CITY OF SARATOGA SPRINGS
DESIGN REVIEW COMMISSION

Design Review Commission Meeting – Wednesday, November 16, 2016

A. 2016.075 Obstarczyk Garage Demolition

147 Spring Street, Advisory Opinion to ZBA on the demolition of a contributing structure and reconstruction of a garage within the Urban Residential-3 District.

21

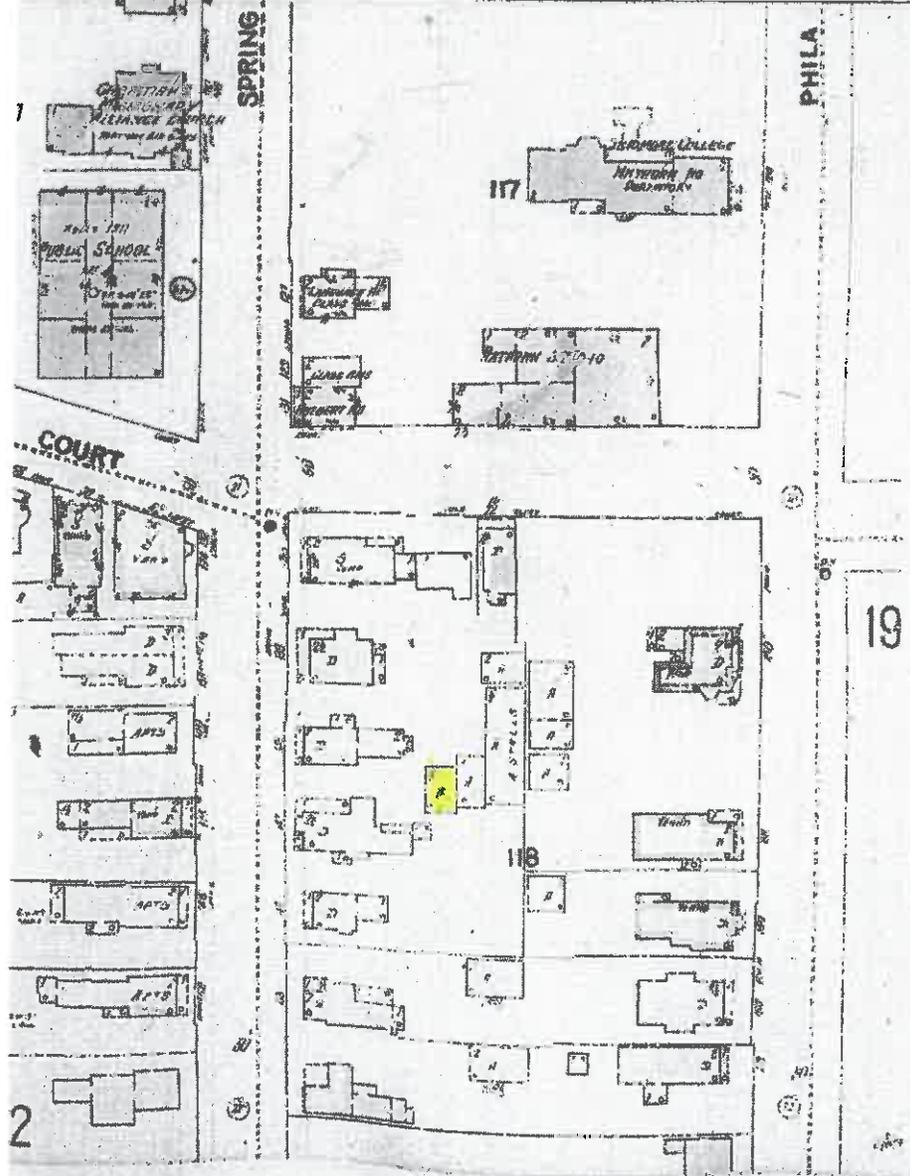
The Queen Anne style house located at 147 Spring Street was constructed circa 1867. Research indicates that the house originally shared the lot with 143 Spring Street and had three accessory buildings, including a large stable. The structure that the applicant is proposing to demolish was constructed between 1876 and 1888 when it first appears on the 1888 Burleigh Bird's Eye View Map. Please see enclosed documentation. The accessory structure at 147 Spring Street is the *only one* of the accessory structures that remains from the two properties. Both the house and the accessory structure are "contributing buildings" to the East Side Historic District listed on the National Register of Historic Places.

The Foundation objects to the demolition of the historic accessory structure. Historic carriage houses, stables, and other accessory structures throughout Saratoga Springs are threatened with demolition-by-neglect and removal. They are important cultural resources of the history and development of our community and should be preserved to the fullest extent possible.
